ADDENDUM NO. 3

DATED: November 14, 2024

PROJECT:	WSD New Sr. High School	**DATE:**	11/14/2024
OWNER:	Wynne School District	**PROJECT NO:**	A-23010
TO:	Gary Hoyt Nabholz Construction	**CONTRACT FOR**:	General Construction

SHEET NUMBER
C1.06

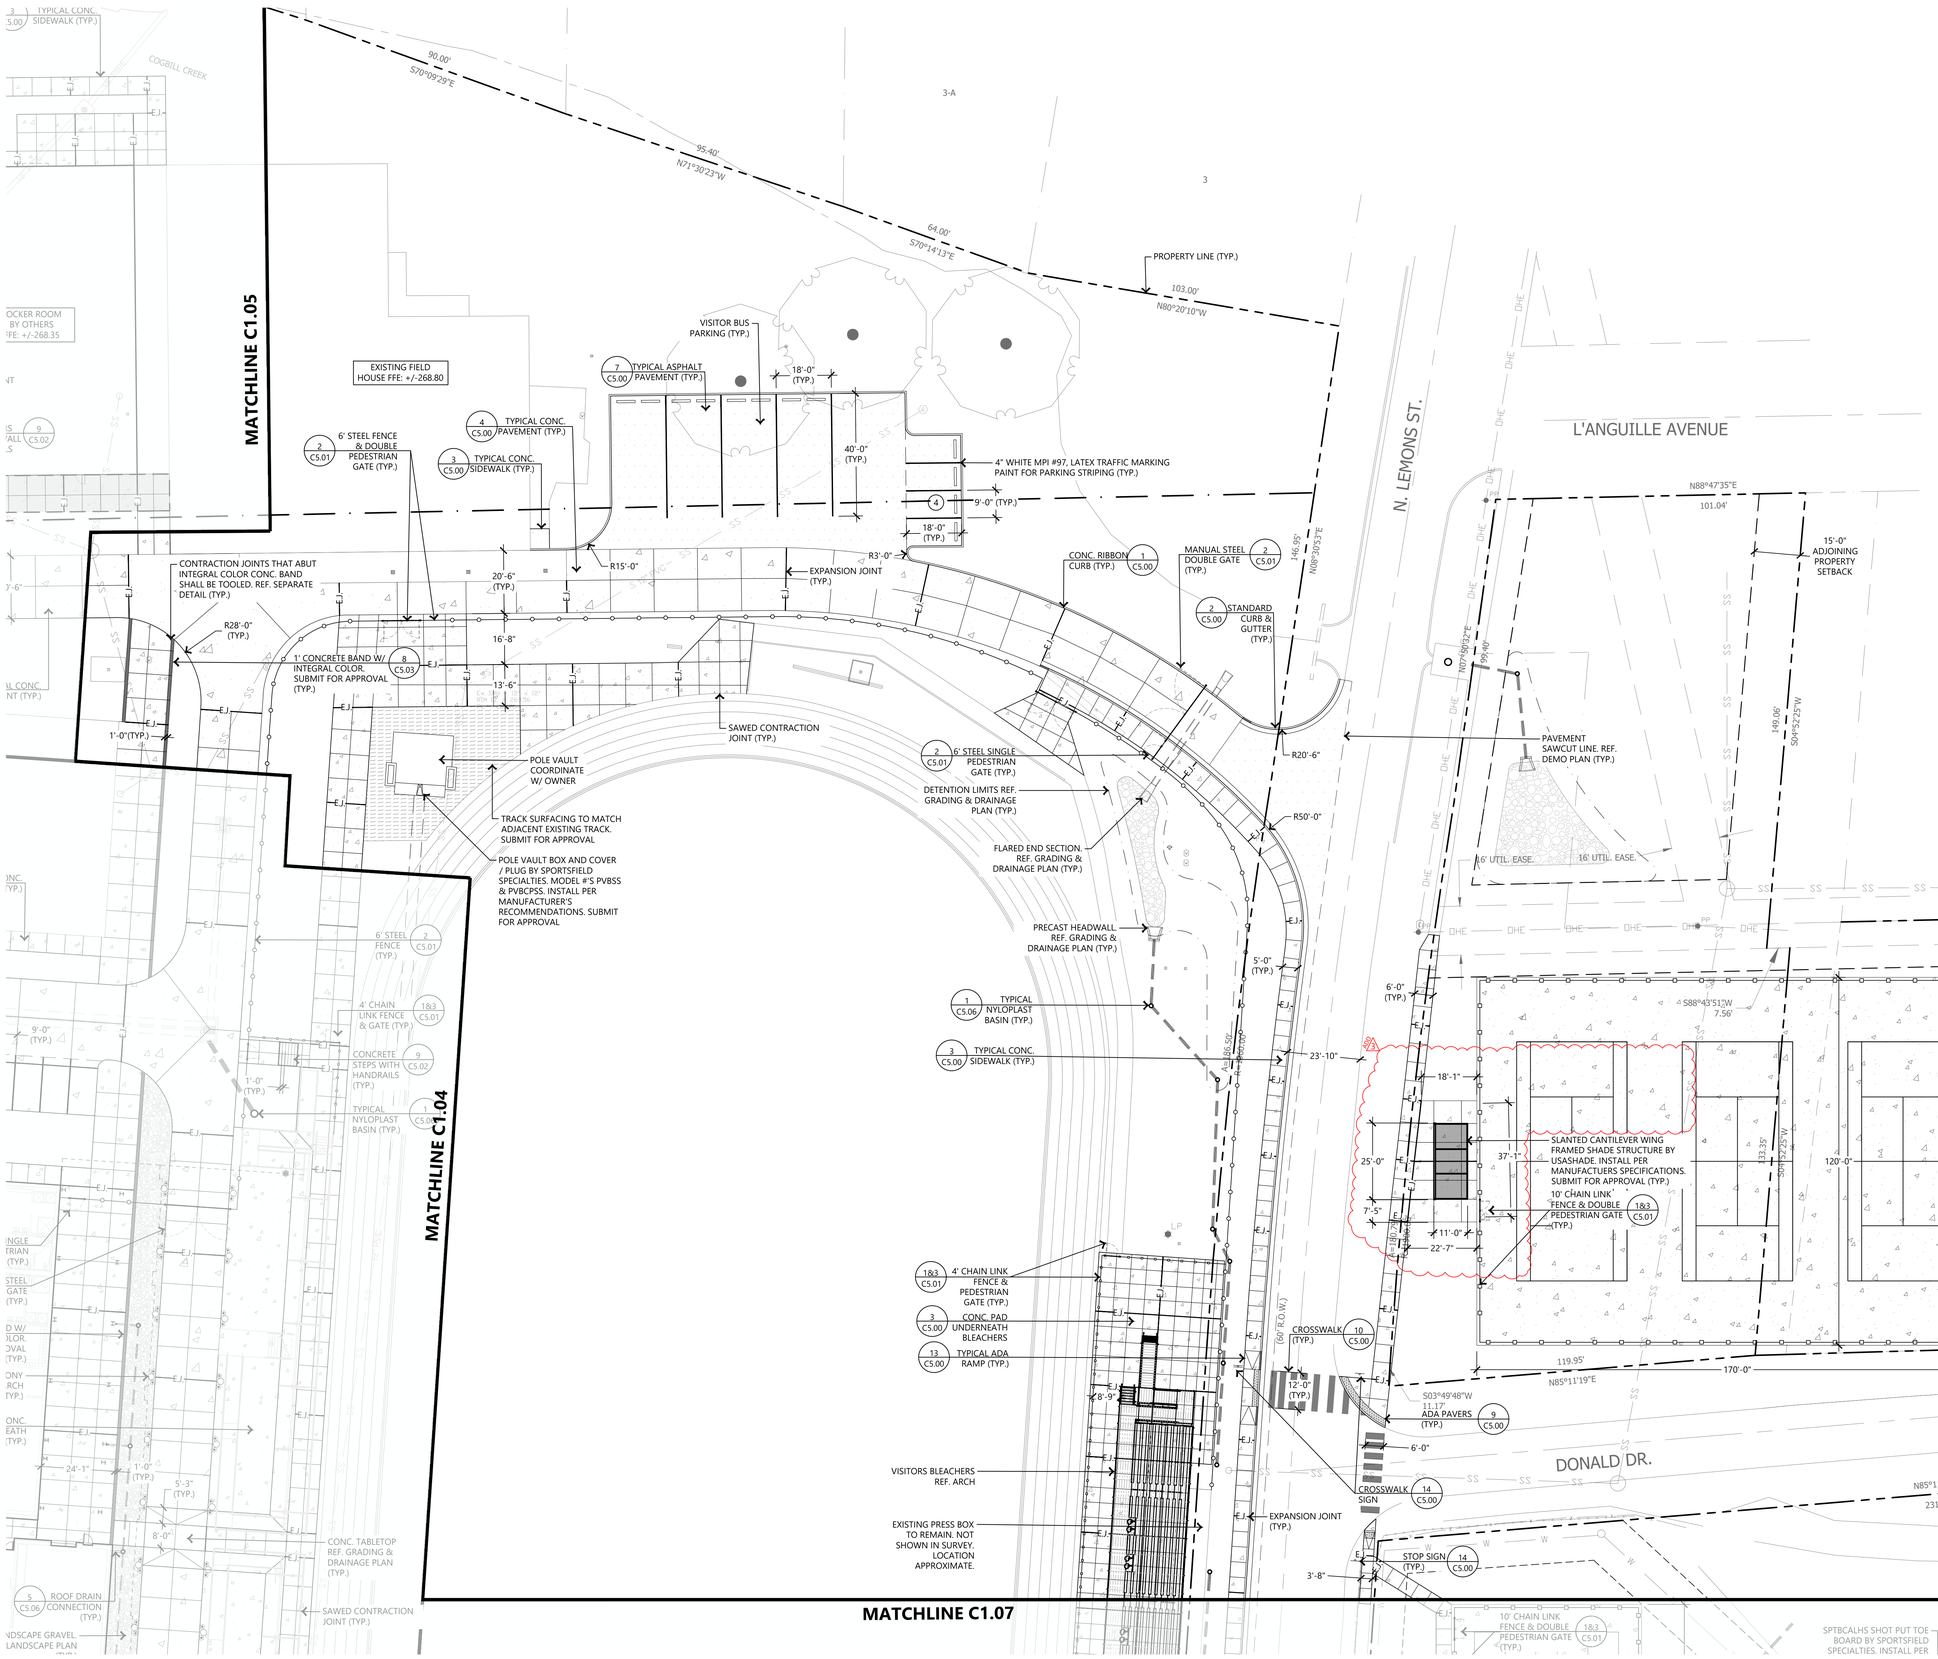
6. Sheet C1.05 SITE PLAN: Drawing has been updated and revised as indicated on drawing sheet.
7. Sheet C1.06 SITE PLAN: Drawing has been updated and revised as indicated on drawing sheet.

SHEET NUMBER
C1.07

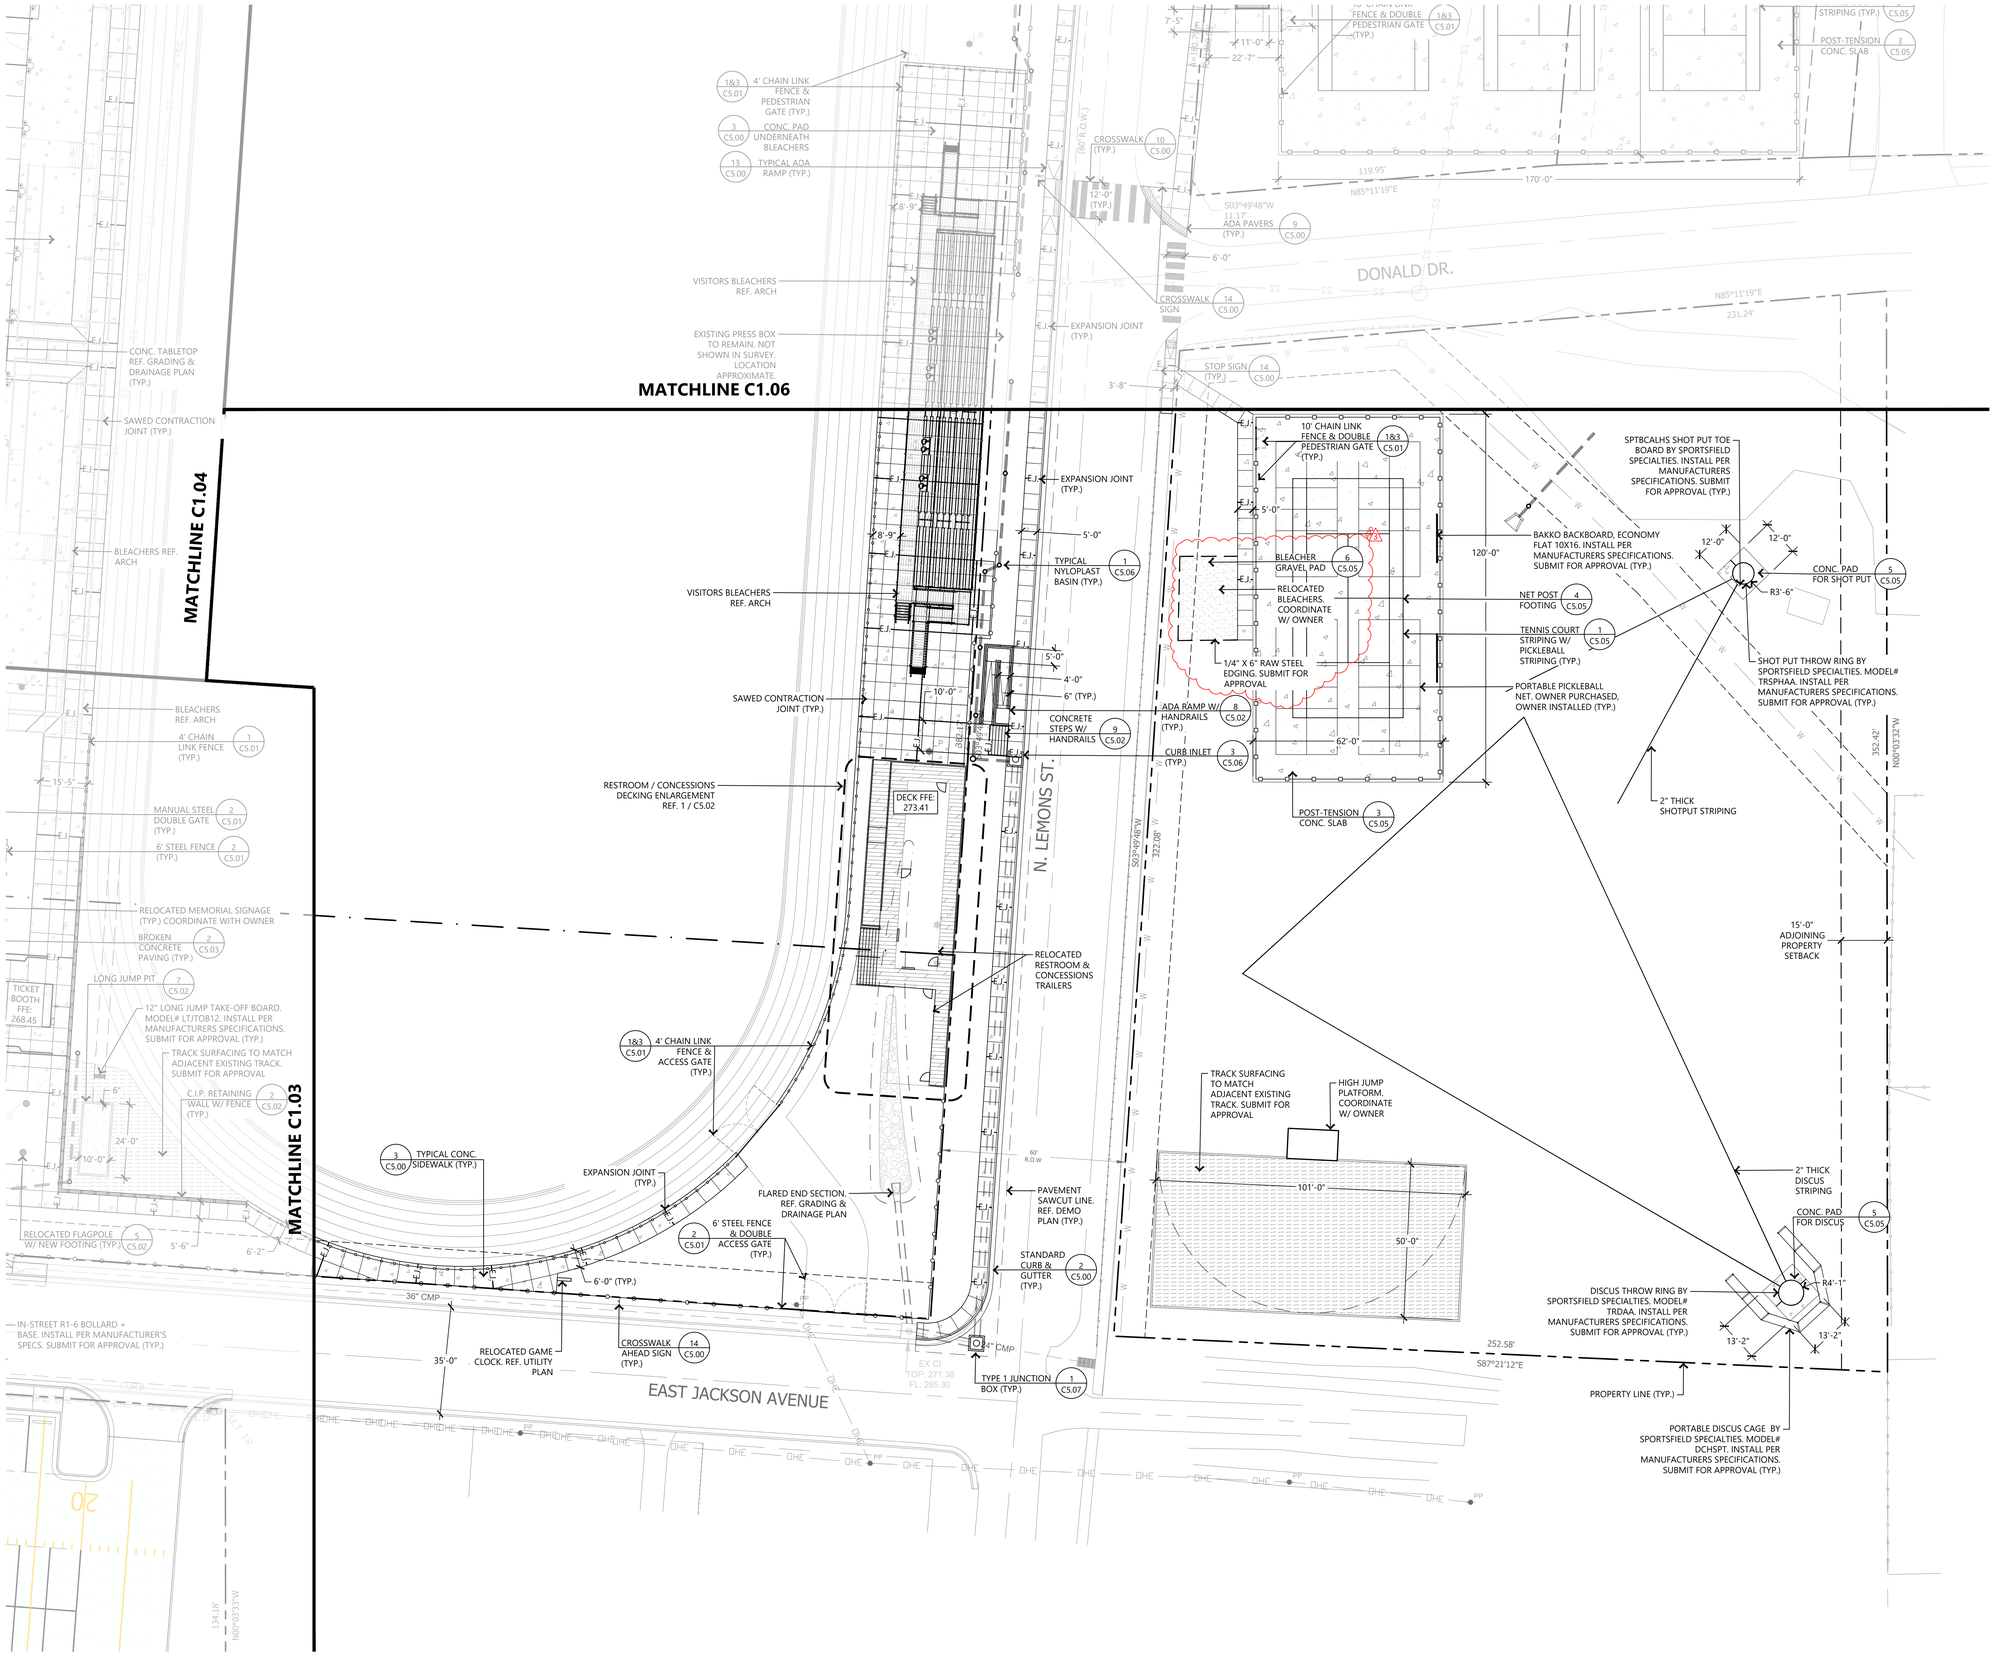
8. Sheet C1.07 SITE PLAN: Drawing has been updated and revised as indicated on drawing sheet.
9. Sheet C2.00 OVERALL UTILITY PLAN: Drawing has been updated and revised as indicated on drawing sheet.

SHEET NUMBER
C2.01

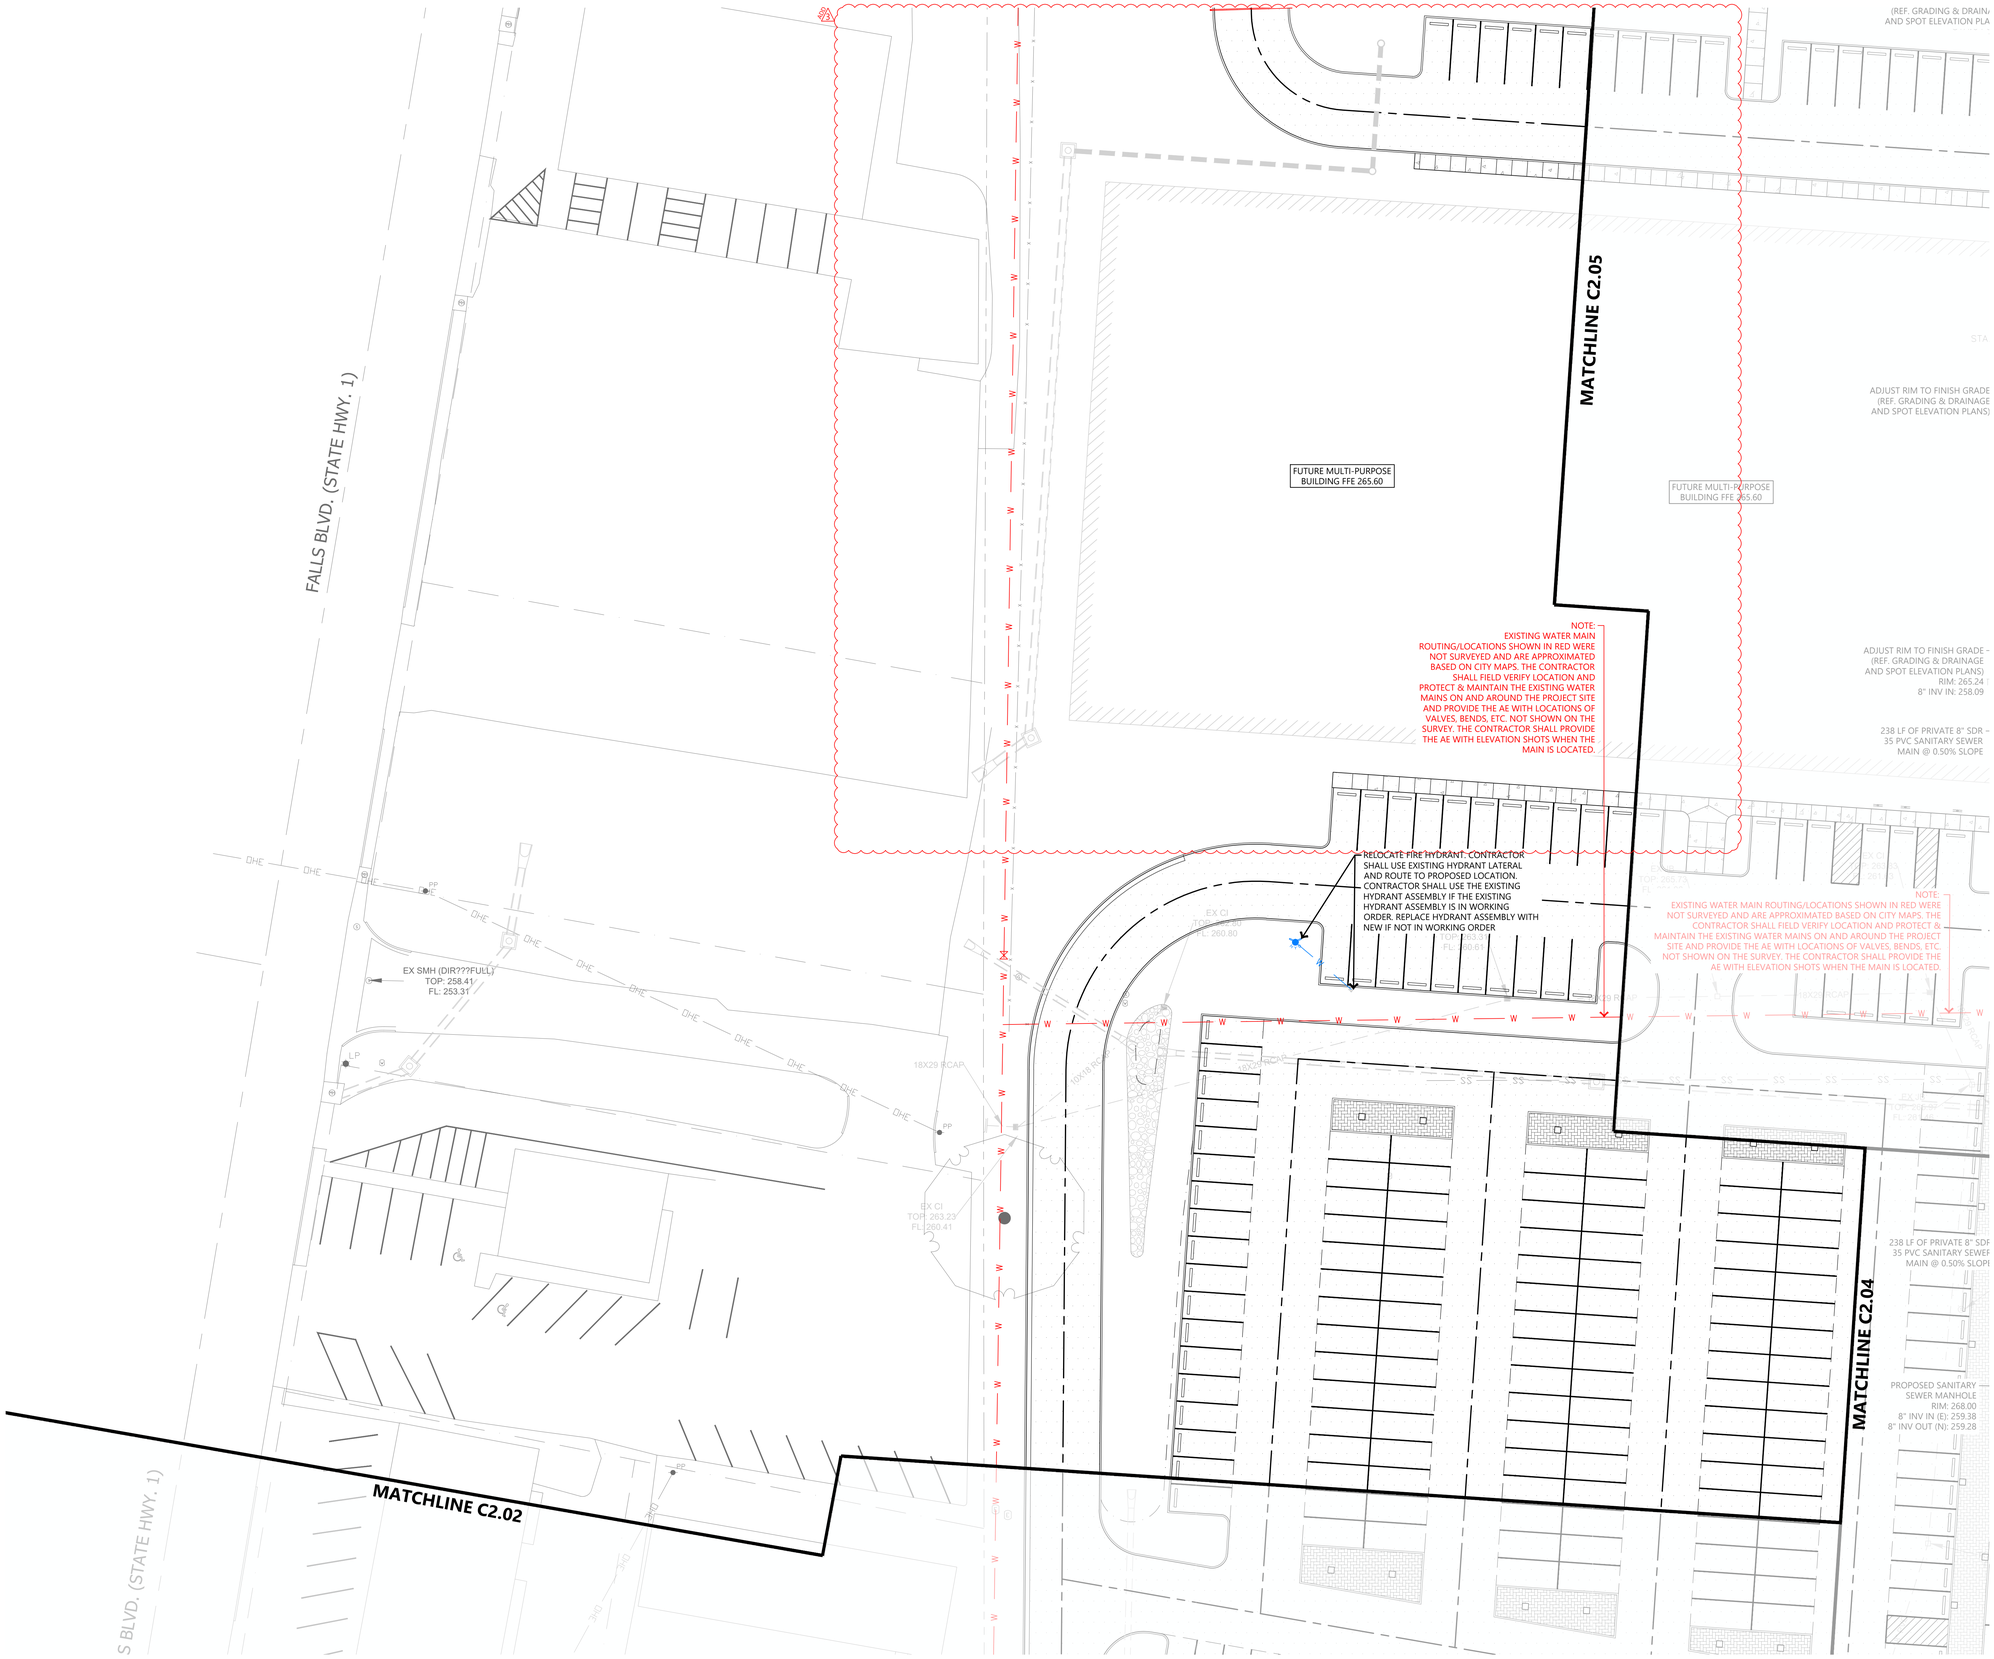
10. Sheet C2.01 UTILITY PLAN: Drawing has been updated and revised as indicated on drawing sheet.
11. Sheet C2.05 UTILITY PLAN: Drawing has been updated and revised as indicated on drawing sheet.
